**2024 Master Plan Proposal to
City of Puyallup, Washington**

August 05, 2024

- Civil Engineer: David Nason, PE, Principal
AHBL
2215 N 30th Street, Ste 200
Tacoma, WA 98403
Telephone: 253.383.2422
Email: dnason@ahbl.com
- Request: Approval of a Master Plan, as governed by Chapter 20.88 of the City of Puyallup Zoning Code, to approve a multi-phased plan calling for construction of approximately 1,012,000 gross square feet (gsf) of new space, bringing total on-campus development up to 2.2 million gsf by 2043, with companion submissions for:

**GOOD SAMARITAN
 HOSPITAL
 PROJECT LIMITS**

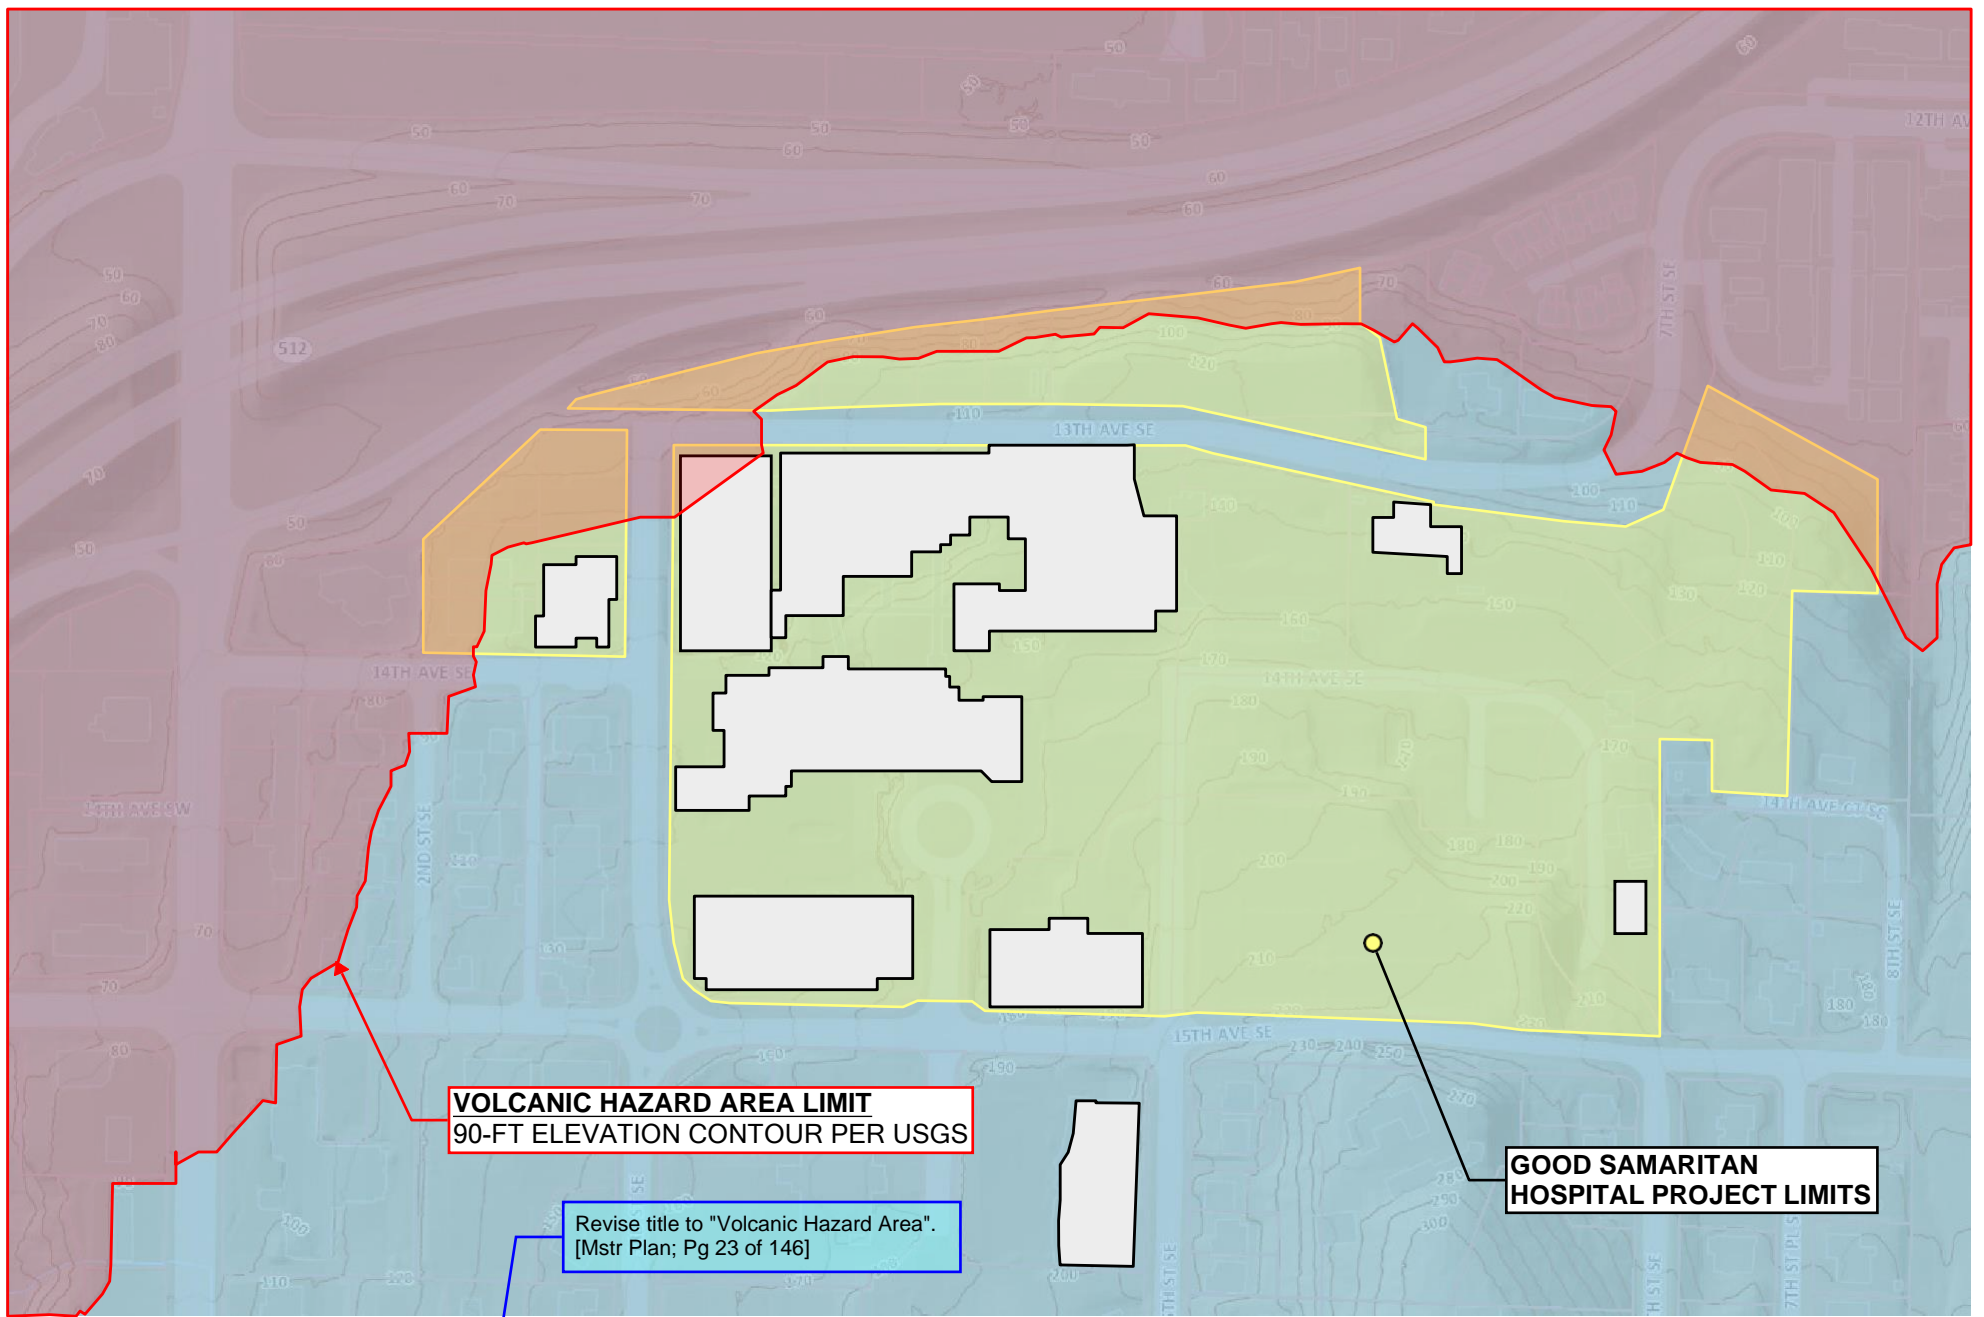
Revise title to "Volcanic Hazard Area".
 [Mstr Plan; Pg 23 of 146]

GOOD SAMARITAN
HOSPITAL PROJECT LIMITS

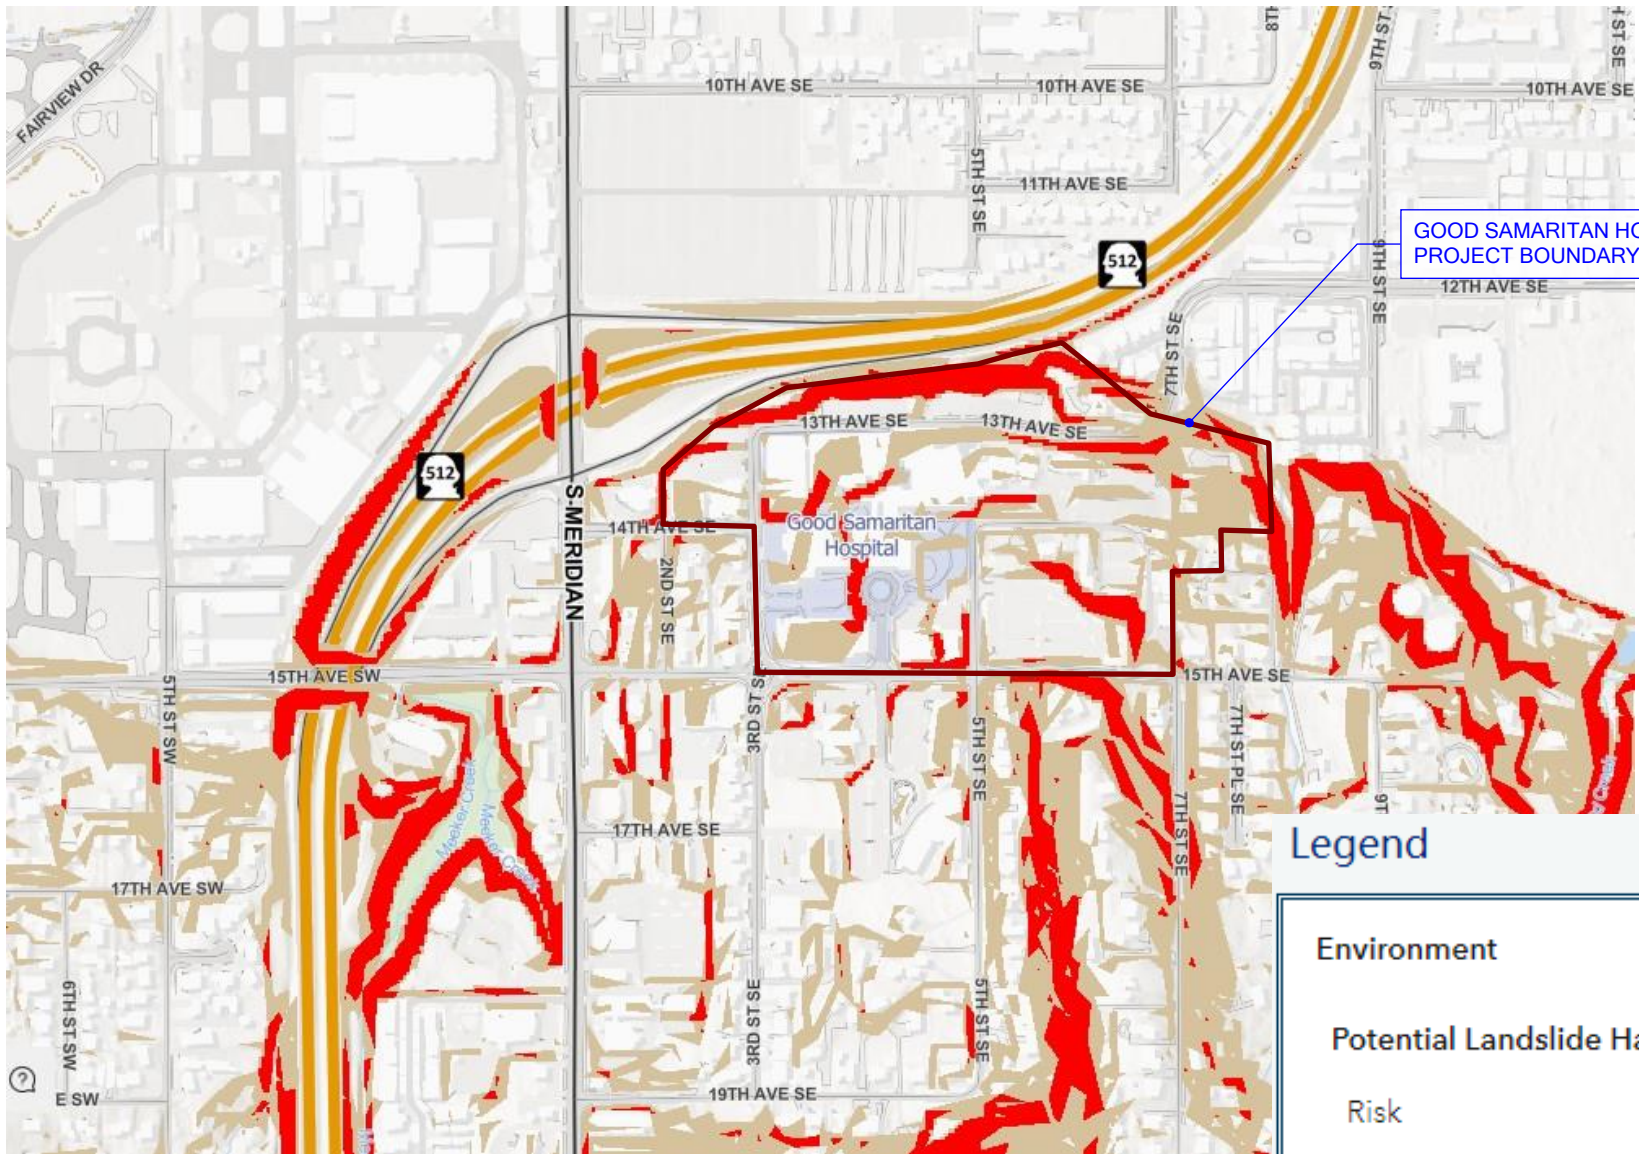
Revise title to "Landslide Hazard Area".
[Mstr Plan; Pg 24 of 146]

MULTICARE GOOD SAMARITAN HOSPITAL MASTERPLAN
 EXISTING UTILIT MultiCare Good Samaritan Hospital Master Plan 2024

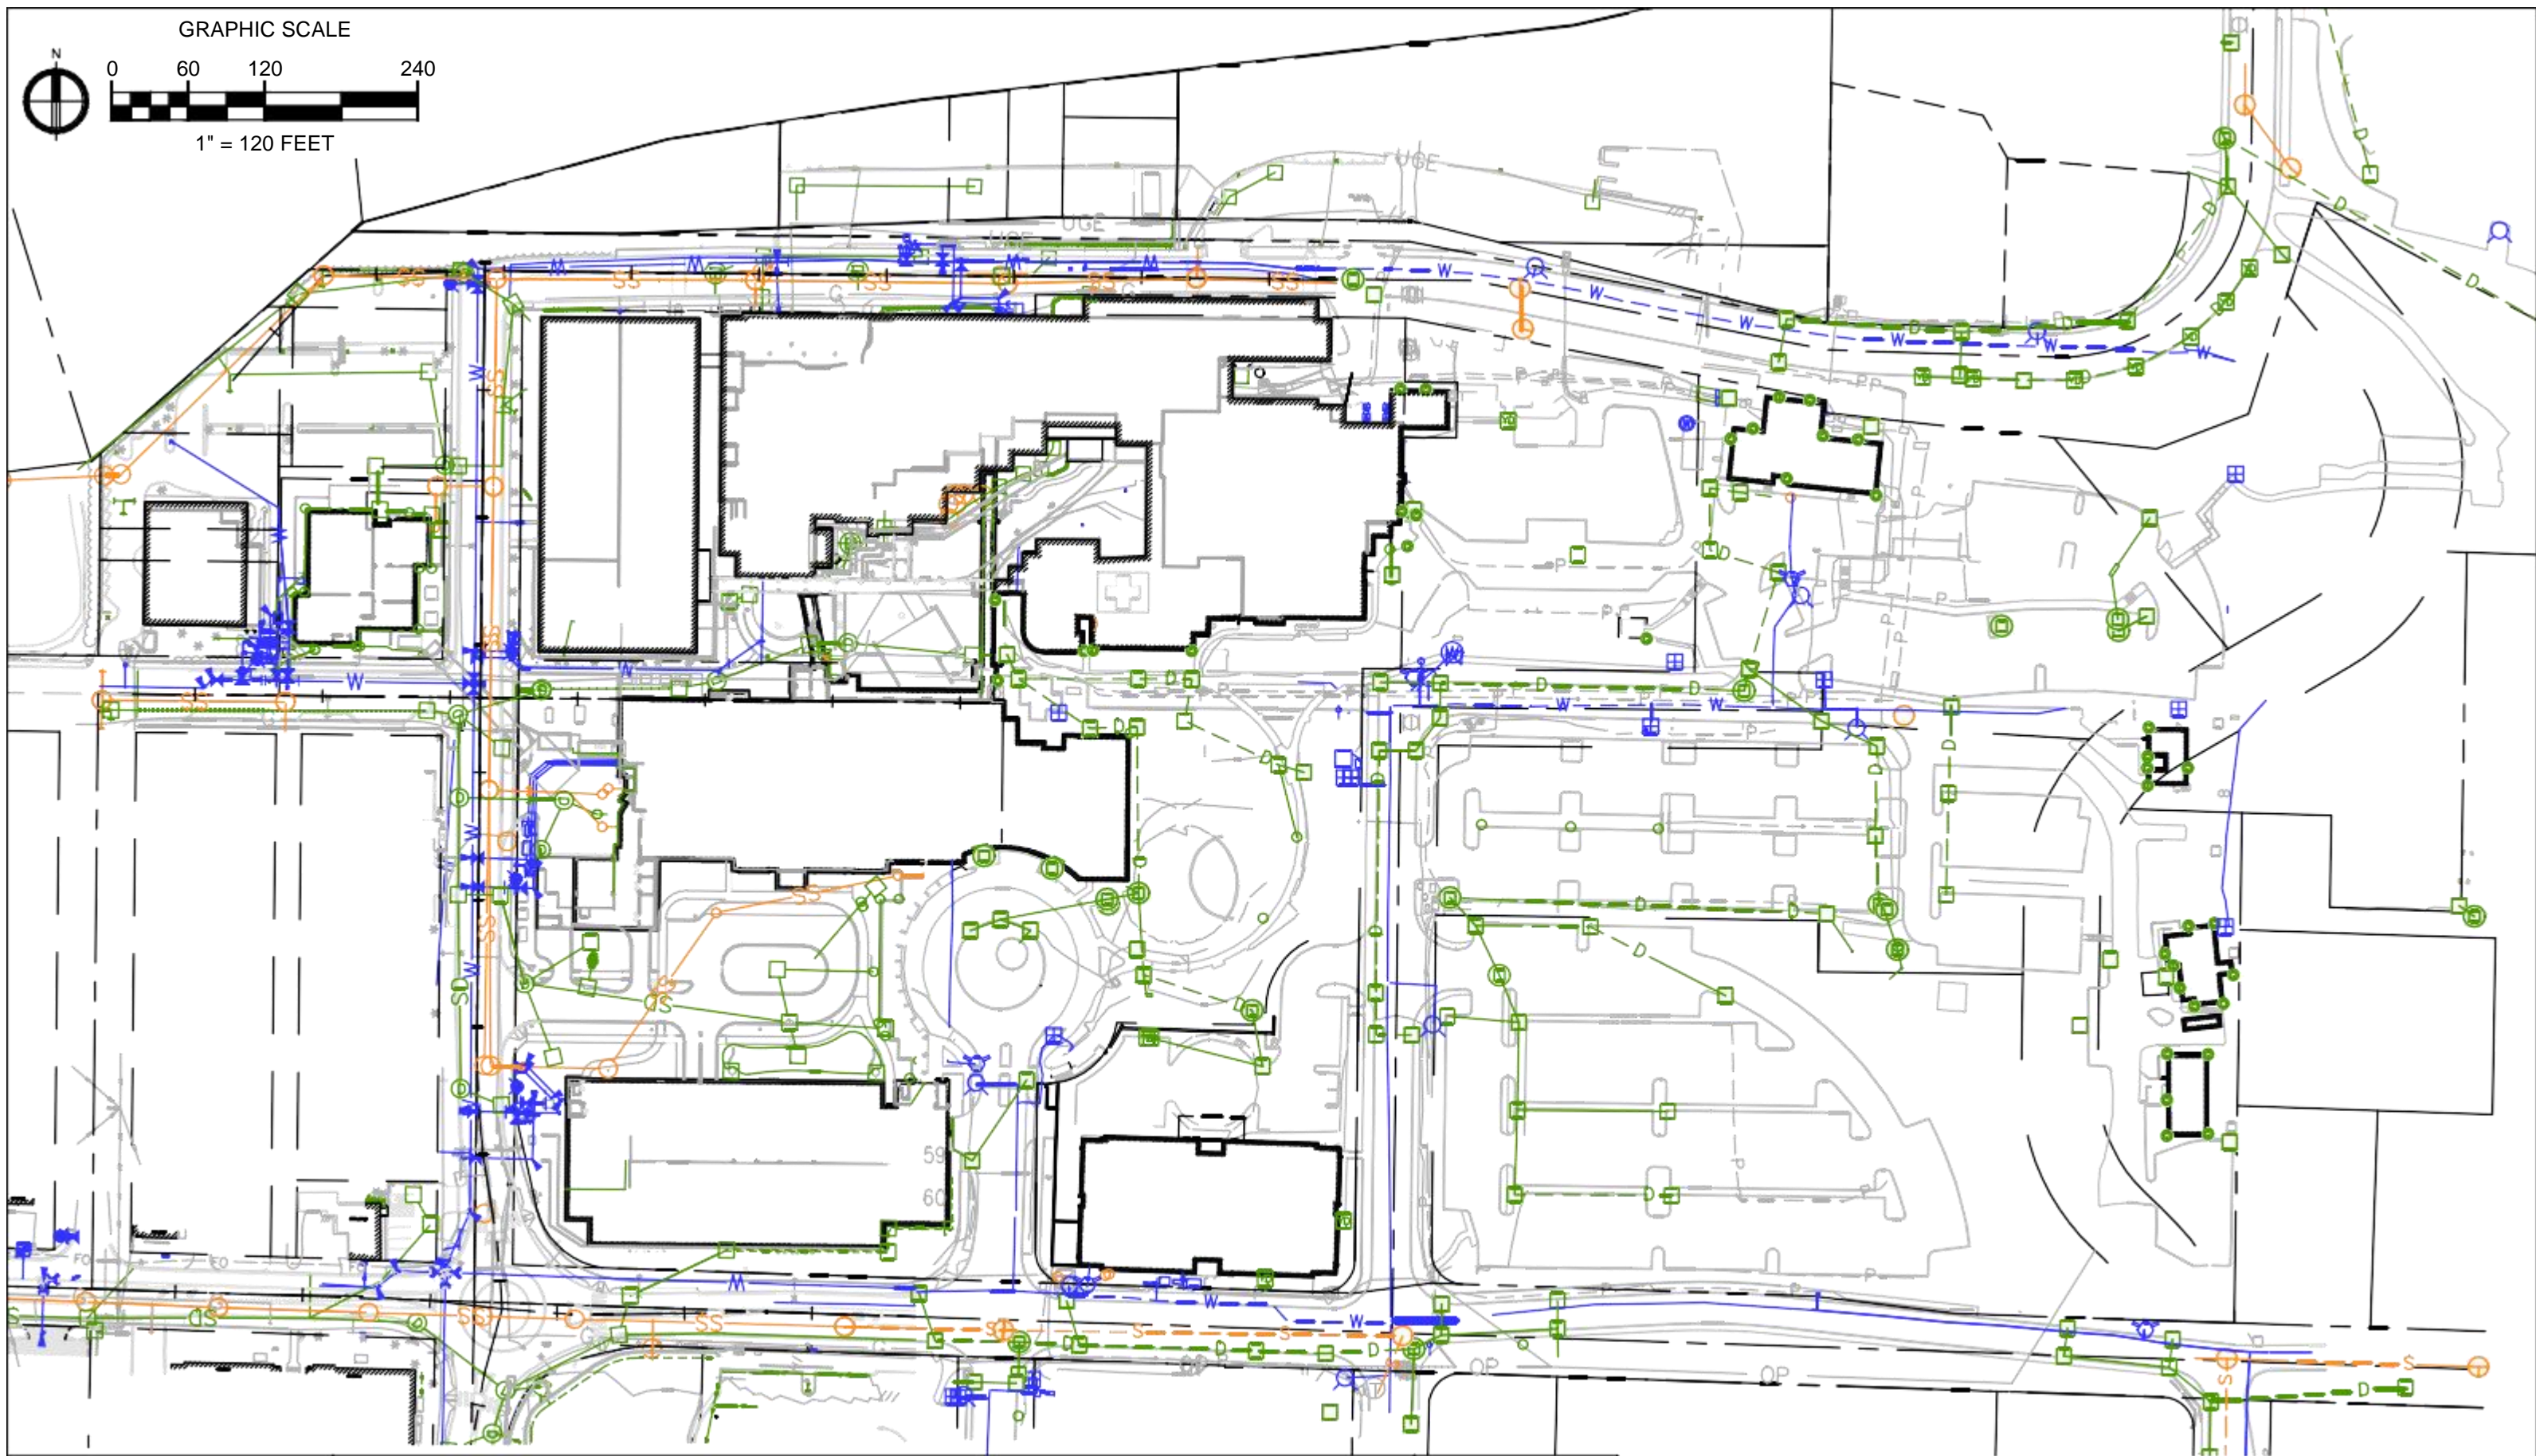
Revise title for clarity.
 [Mstr Plan; Pg 31 of 146]
